YAMANAKA, et al., 10/684,684  
27 June 2008 Amendment  
Responsive to 27 February 2008 Office Action

**AMENDMENTS TO THE DRAWINGS:**

### REMARKS

**FIG.11** into the deeper groove (e.g., the axial groove 2e).

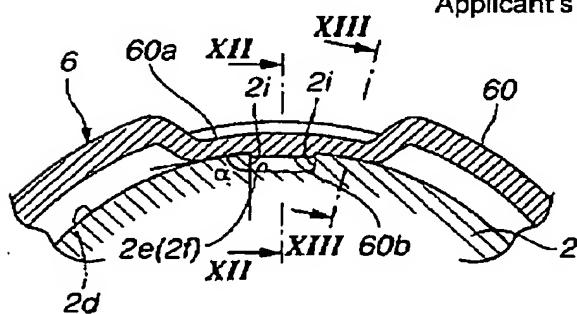
FIG. 11 had the "(2f)" reference number removed, and also an extraneous line within the indented portion removed.

Regarding the Office Action assertion (first two lines of last paragraph on page 2 of the 27 February 2008 Office Action) that "the top surface of the caulked portion in the axial groove in FIG. 11 should be dented. The bottom surface of the caulked portion in the axial groove has a projection but not the top surface and therefore has to be shown.", traversal is appropriate. More particularly, Applicant's FIGS. 15a-b caulking tool has no portion to create the allegedly-needed "dent". Regarding a "projection" extending into the axial groove, such may easily be accomplished through sufficient pressure with Applicant's FIG. 15a-b caulking tool, causing pressurized plastic deformation of the caulked portion into the axial groove without causing any corresponding dent in the top surface of the caulked portion. Reconsideration and withdrawal of such Office Action assertion, are respectfully requested.

Applicant's FIG. 11 shows an example caulked

projection extending beyond the circumferential groove 2d into the deeper axial groove 2e.
